Access Compliance Report

Public Rights-of-Way

(Curb Ramps)

Intersection ID: 17405	Main Street: RIDGEWOOD_AV	Cross Street: WESTFIELD_RD	Location: NW
ADA ID: 1AC2CE356566	Ramp Type: Perp	Initial Pass/Fail: Fail	Overall Compliance: No
		Severity Score: 12.5

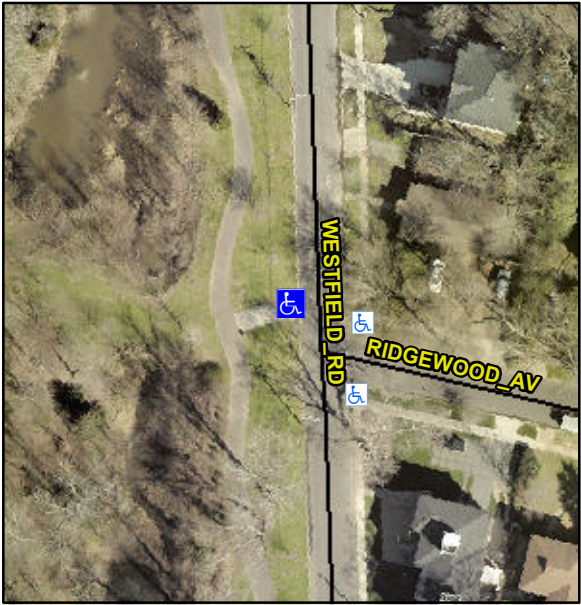
Codes/Mitigation Info/Possible Solution			Field Measurements/Component Compliance		
	Possible Solutions:		Compliance	Description	Data
	Remove & Replace Entire Ramp.		No	Ramp Length (in)	80.0
			Yes	Ramp Width (in)	120.0
			N/A	Flare Type LT	N/A
			N/A	Flare Slope LT (%)	N/A
			N/A	Flare Traversable LT?	N/A
			N/A	Landing Length (in)	N/A
			N/A	Landing Width (in)	N/A
			N/A	Landing Slope (%)	N/A
			N/A	Landing X Slope (%)	N/A
<p>Surveyor Notes:</p> <p>N/A</p> <p>PROW/ADA:</p> <p>Not Found, R304.2.2</p>			N/A	Flare Type RT	N/A
			N/A	Flare Slope RT (%)	N/A
			N/A	Flare Traversable RT?	N/A
			N/A	DWS Provided?	N/A
			N/A	DWS Contrast?	N/A
			N/A	DWS Length (in)	N/A
			N/A	DWS Full Width?	N/A
			N/A	DWS Offset (in)	N/A
			N/A	Gutter Ponding?	N/A
			N/A	Gutter Lip Ht (in)	N/A
			No	Painted X Walk1?	N/A
				X Walk 1 Direction	To SE
			N/A	X Walk 1 Width (in)	N/A
				X Walk 1 Slope (%)	6.1
				X Walk 1 X Slope (%)	3.5
			N/A	Ramp inside XWalk1?	N/A

N/A	Road Slope (%)	N/A
			N/A	Road X Slope (%)	N/A
			N/A	Any Obstructions?	N/A
				Obstruction Type	
Total Cost:					
		\$ 1850.00			
			N/A	Clear Space?	N/A
			N/A	Clear Space to XWalk (in)	N/A
			N/A	Storm Grate/Utility Hazard?	N/A
				Storm Grate/Utility Type	
			N/A		N/A
			Yes	Surface Condition? (G/P)	Good
